Title: Upgrade Intercooler Strut Attachment		
AG-SB-2025-01-B-EN	Effective Date: 01.11.2025	Compliance Category:
Applicability		A - MANDATORY B - RECOMMENDED C - OPTIONAL
Aircraft type & model: AutoGyro Calidus with ROTAX® 916is engines	Affected Serial number(s): C00588 C00592 C00589 C00593 C00590 C00596 C00591	
The maintenance manual to be referenced is this stated or subsequent issue.		As per AutoGyro website
<p>This form is the response from AutoGyro GmbH either against a problem found in the product in service requiring a containment or rectification action, or as service information for aircraft modification incorporation. For help, contact airworthiness@auto-gyro.com.</p>

Reason and overview of the Service Bulletin (cause of problem if known)

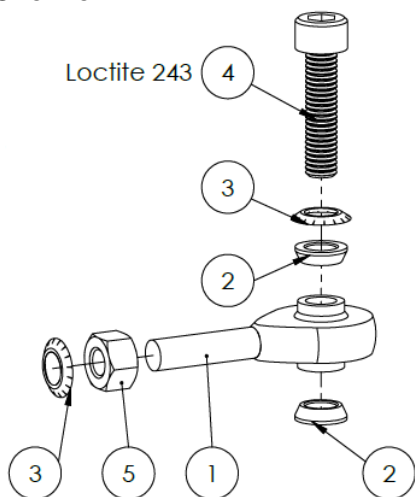
Market feedback has shown that this strut attachment may occasionally fail due to engine vibration. The failure has no effect on airworthiness or flight safety, but is undesirable. This Service Bulletin describes the retrofitting of an improved version in which the rigid eyebolt is replaced with a rod end. This allows for better absorption of the natural vibrations of the affected components.

- 4) Remove the eyebolt from the support strut, it is no longer required

- 5) Overview:

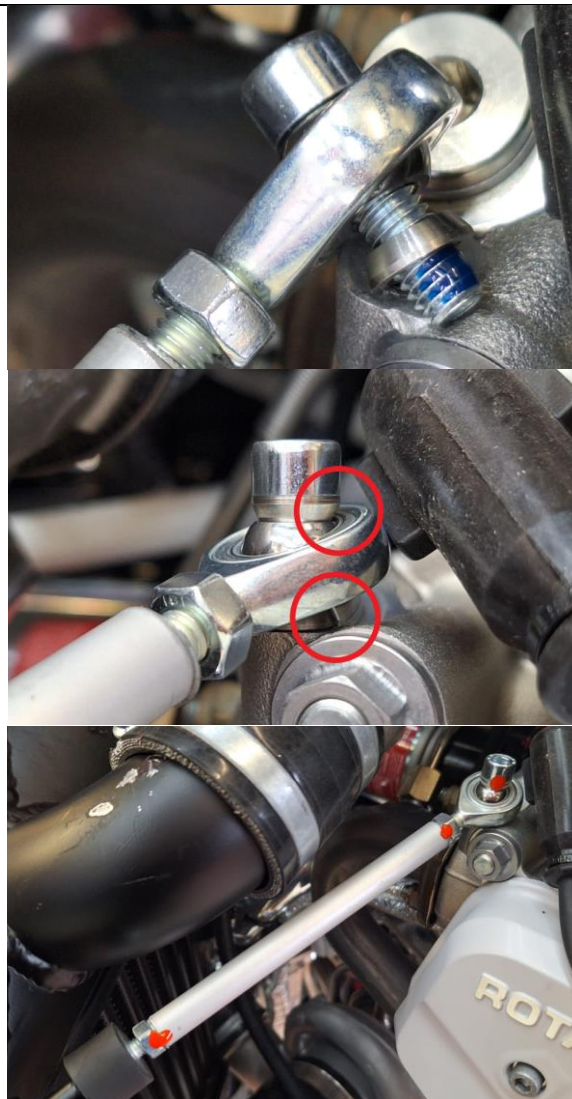
- 6) Pre-assemble the ①rod end with ⑤nut and ③safety washer according to the drawing above and screw it into the support strut **at least 5 turns/threads**.

- 7) Align the rod end over the thread on the cylinder head to ensure a stress-free installation. Adjust the length by screwing it in or out. **However, at least 5 turns/threads must always remain in the support strut.**

8) Fit the ④screw according to 5) with ②spacers and ③safety washer and apply Loctite® 243

9) Tighten the screw. **Inspection:** The outer part of the rod end must not contact the installed conical spacers or the engine block and must remain freely movable.

10) Tighten the ⑤nut to lock it against the support strut, mark the support strut and ④screw with engineer's paint.
